From: [REDACTED]
To: [REDACTED] [Merrimu PSP \(DTP\)](#)
Cc: [REDACTED]
Subject: [EXTERNAL] Merrimu PSP - Landowner Submission - [REDACTED] - Drainage
[24612E]
Date: Thursday, 9 April 2026 6:26:41 PM
Attachments: [image001.png](#)
[24612E-Merrimu PSP-drainage-submission_April 2026_v0.pdf](#)

Our Ref: 24612E

LANDOWNER DRAINAGE SUBMISSION: MERRIMU PRECINCT STRUCTURE PLAN (PSP)

Figure 1: Subject Land within Merrimu PSP

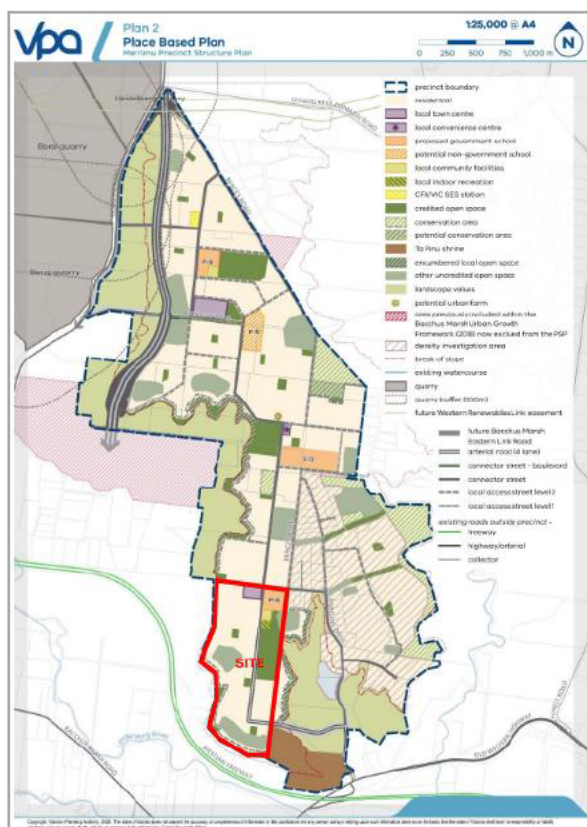
We refer to the above matter and write on behalf of the landowner, [REDACTED] in relation to land identified as [REDACTED] within the exhibited draft Merrimu Precinct Structure Plan (PSP). We represent the landowner in relation to the landholding shown in Figure 1 below.

This submission focuses on drainage-related matters affecting the land. It represents a high-level position based on currently available information, noting that:
